DEPARTMENT OF TRANSPORTATION**National Highway Traffic Safety Administration**

[Docket No. NHTSA–2019–0105]

Denial of Motor Vehicle Defect Petition

ACTION: Denial of petition for a defect investigation.

Figure 1. Pre-crash operator control data, from top-to-bottom: vehicle speed, accelerator pedal position, brake pedal application, brake master cylinder pressure, and steering angle.

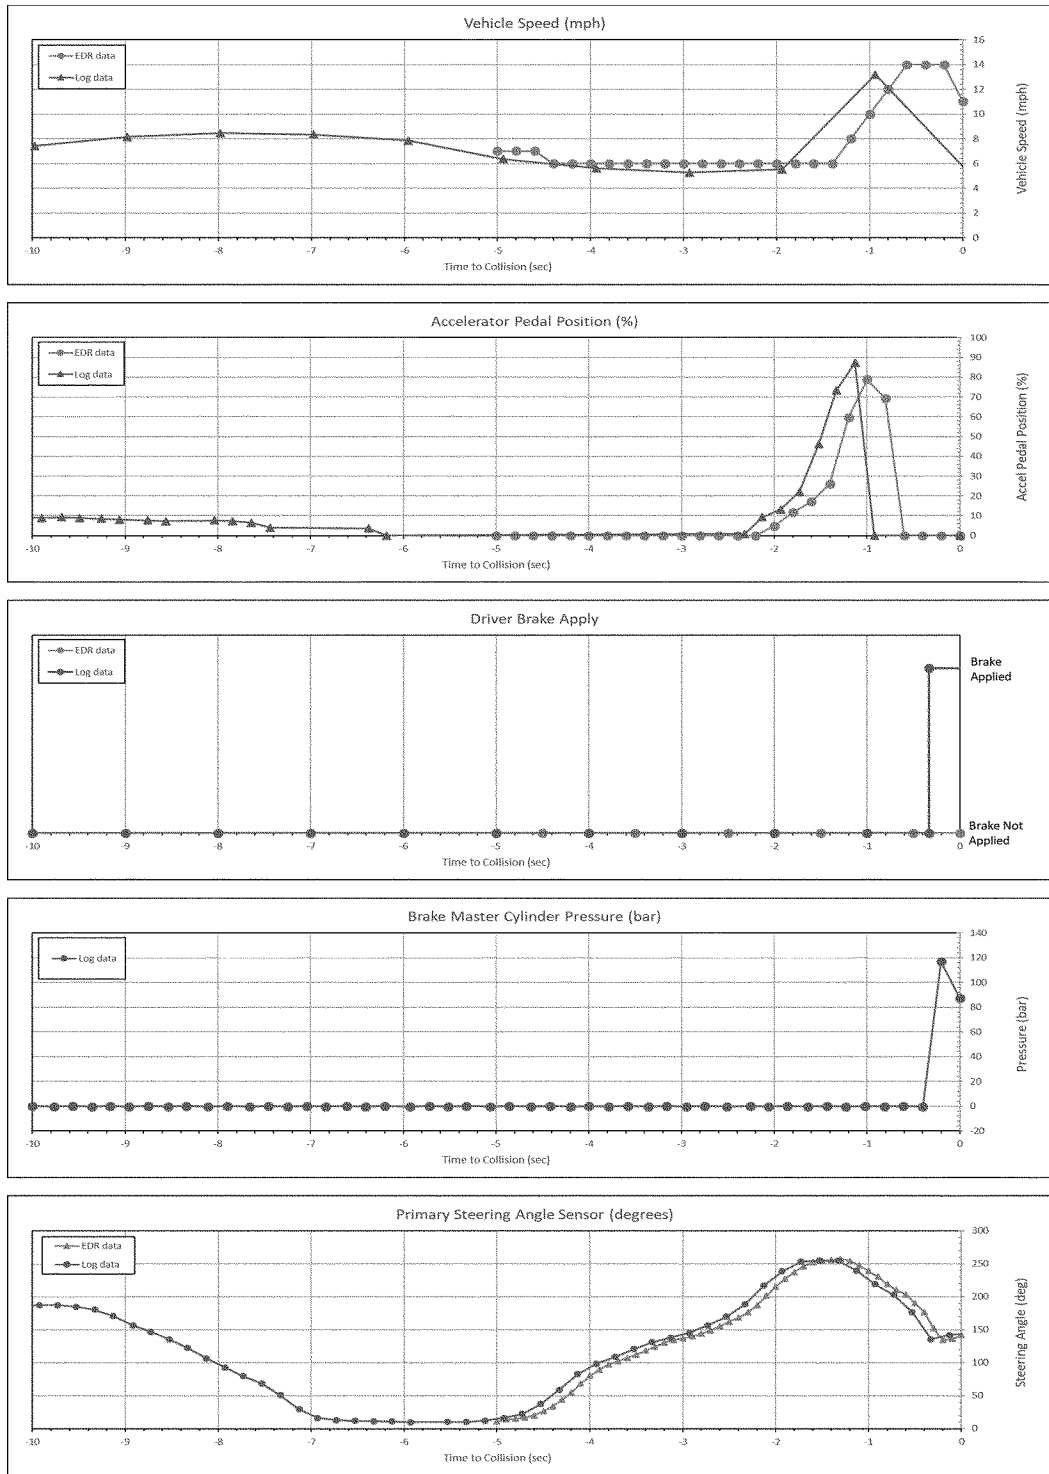
- The vehicle acceleration data used by Dr. Belt in his analysis was reported with the polarity reversed. In other words, the data shows the vehicle decelerating when it was accelerating and accelerating when it was decelerating. As shown in Figure 1, the vehicle first accelerates in response to a large accelerator pedal application, then decelerates in response to the late brake

- The evidence shows that the brake light switch functioned as designed in the event analyzed by Dr. Belt (see Figure 1).
- The ESC and Traction Control systems cannot request positive torque in the subject vehicles.
- The APPS data recorded in the EDR report and data log show the physical position of the accelerator pedal (see section 3.5 System Safeguards). There is no other source for the accelerator pedal data.
- The vehicle does not veer to the left at any point during the crash event (see Figure 1 and section 3.3.4 ODI Analysis of Event Video File).
